## CITY OF KELOWNA

# MEMORANDUM

APPLICATION NO. Z02-1041

PURPOSE: TO REZONE THE SUBJECT PROPERTY FROM RM5 – MEDIUM DENSITY MULTIPLE HOUSING ZONE TO C4 – TOWN CENTRE COMMERCIAL ZONE TO PERMIT THE CONSTRUCTION OF A 2 ½ STOREY, 3,798 M<sup>2</sup> COMMERCIAL DEVELOPMENT

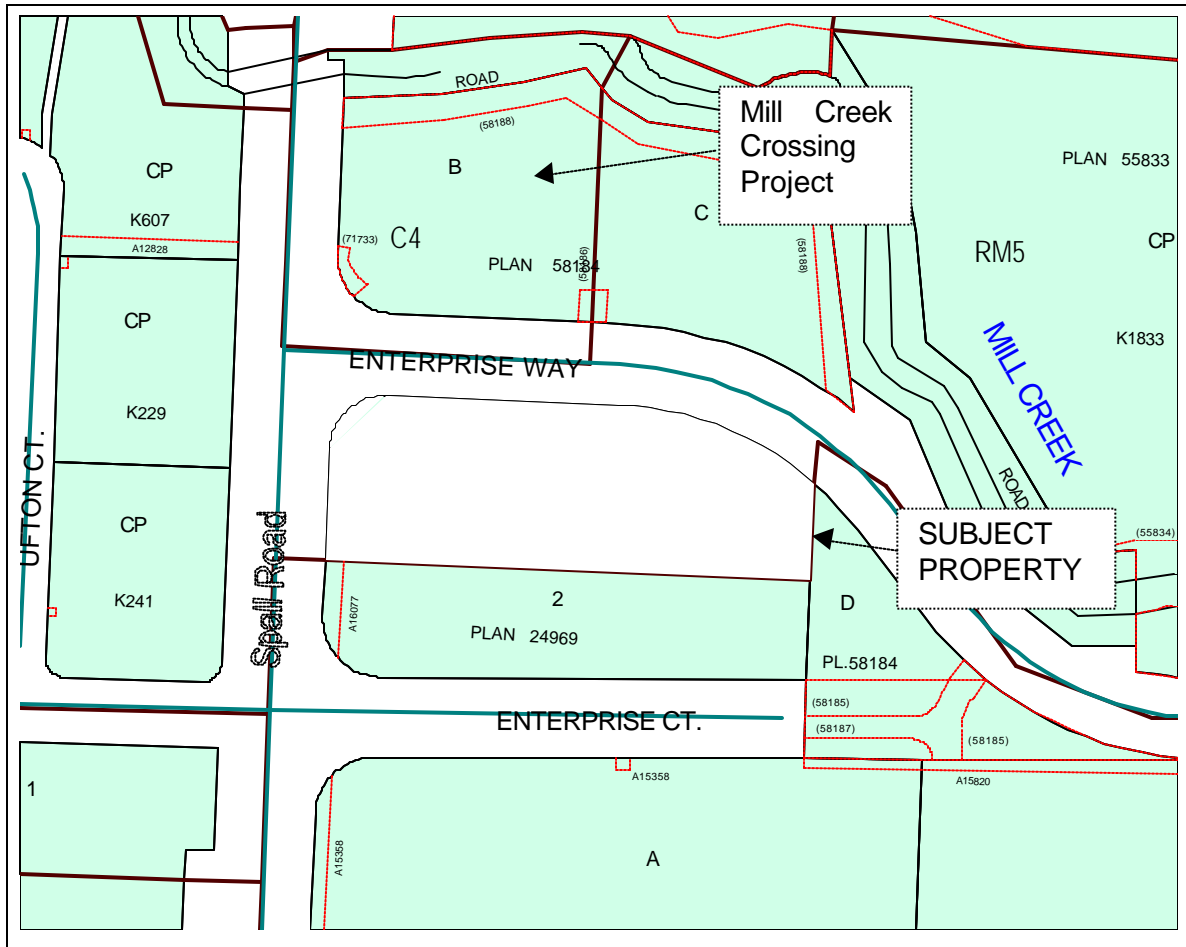
The proposed building is divided into five distinct design elements facing the surface parking lot and Enterprise Way. The form and character of the proposed building incorporates a substantial amount of brick detailing and stucco wall finishes, and utilizes a flat roof profile and strong cornice molding elements. The building facades incorporate a substantial amount of store-front glazing along the ground floor, and include a number of canopy units over the ground floor windows and doors. The roof line is stepped up and down along the frontage to reduce the perceived length of the building, while there are several horizontal steps in the building façade to reinforce the creation of a number of distinct units. The design of the proposed facades utilize brick finishes, reminiscent of early 1900's urban commercial development. The design theme of the façade facing Enterprise Way attempts to replicate a typical streetscape from the turn of the previous

century. The proposed building facades incorporate a variety of details rendered with the brick and include built-out plinth and column details, corbelled cornice details, and additional horizontal design elements rendered in brick above the ground floor windows to replicate period building details up to the parapet walls. The wall areas also include surface mounted lights. The roof areas above some of the single storey high building areas have post and rail style balustrade added to provide for outdoor deck area accessible from the adjacent two storey building areas. The building facades also utilize a number of marquee style canopies above the storefront window glazing on the ground floor.
